ADDENDUM No. 1

ITB No. 4638

Gallup Park Asphalt Path Renovations

DETAIL 1: OPTION A - PROPOSED 10' WIDE BITUMINOUS SHARED USE PATH CROSS SECTION

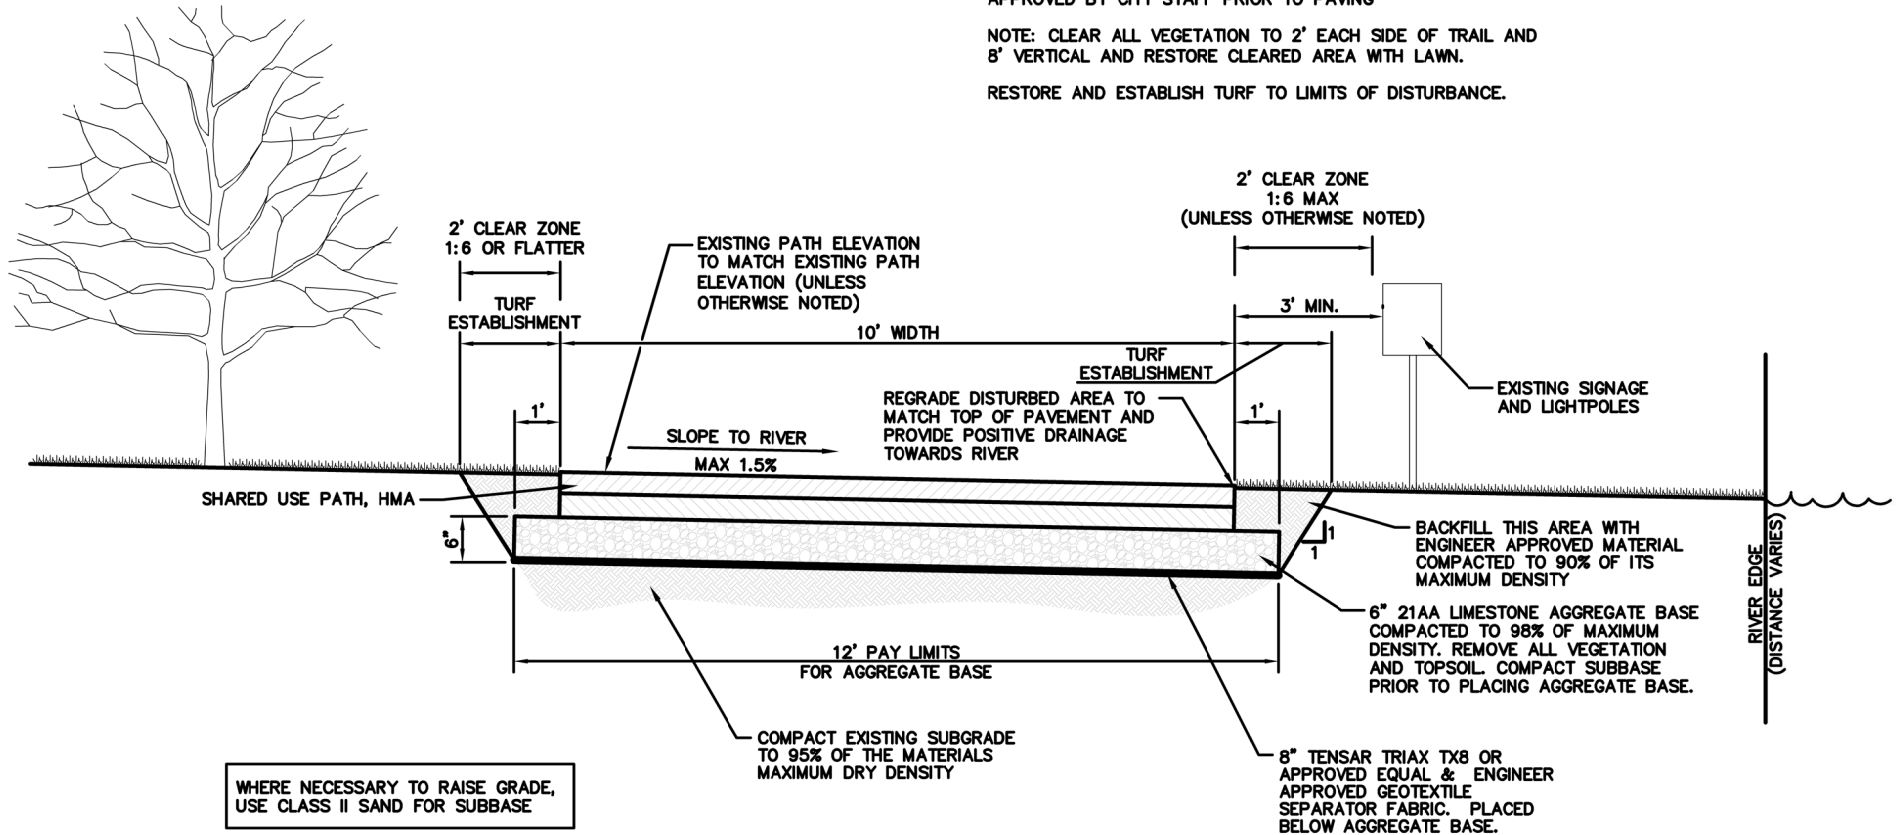
As provided in ITB No. 4638 Bid Document:
DETAIL 1: OPTION A SHARED USE PATH DETAIL
DETAIL 2: OPTION B SHARED USE PATH DETAIL

As updated herein:
DETAIL 1: OPTION A SHARED USE PATH DETAIL
DETAIL 2: OPTION B SHARED USE PATH DETAIL

Comment: The intent with this change is to remove conflicting information between the detail and the specification. Specifically, the depth of the asphalt path was removed. Refer to Detailed Specification regarding information on asphalt path.

- Question 5: Please confirm HMA paving. Plan sheets page 79 and 80 indicate 5" HMA. However, specification page DS-18 indicates HMA, 5E1 (2") and HMA, LVSP (2").

- Answer 5: The specifications on DS-18 should be followed. Conflicting information has been removed from the cross sections.
- Question 6: Cross Section Detail 2: Option B, indicates 6" 21AA Limestone and 4" HMA. Please clarify Bid Form Option B, Item 7 verbiage "Based on estimated removal of 18" Depth.

DETAIL 6: PICNIC TABLE DETAIL

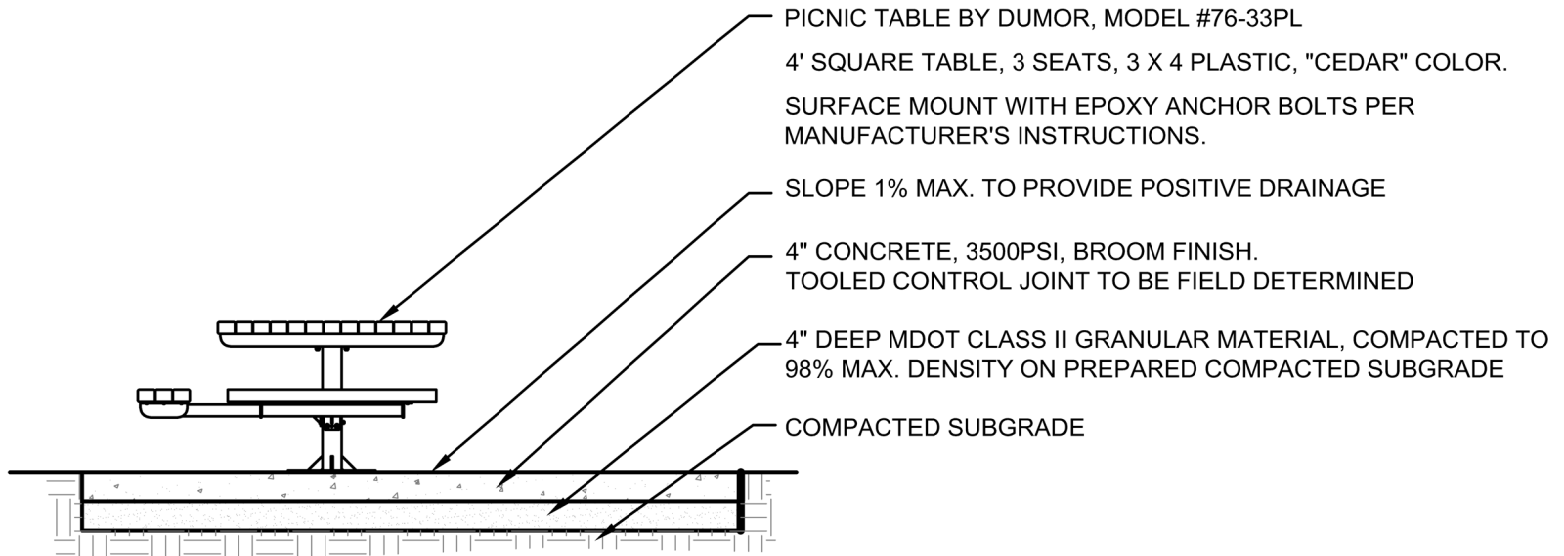
As provided in ITB No. 4638 Bid Document:
DETAIL 6: PICNIC TABLE

As updated herein:
DETAIL 6: PICNIC TABLE

Comment: The intent with this change is to provide additional information. Specifically, dimensions were added to better define the size of the concrete pad underneath of the picnic table.

Question 1: Please confirm Concrete Pad dimensions for "Picnic tables". Plans only show concrete pad dimensions for "Benches".

Answer 1: Concrete Pad dimensions are 135.5" x 104". Detail has been updated to show dimensions.
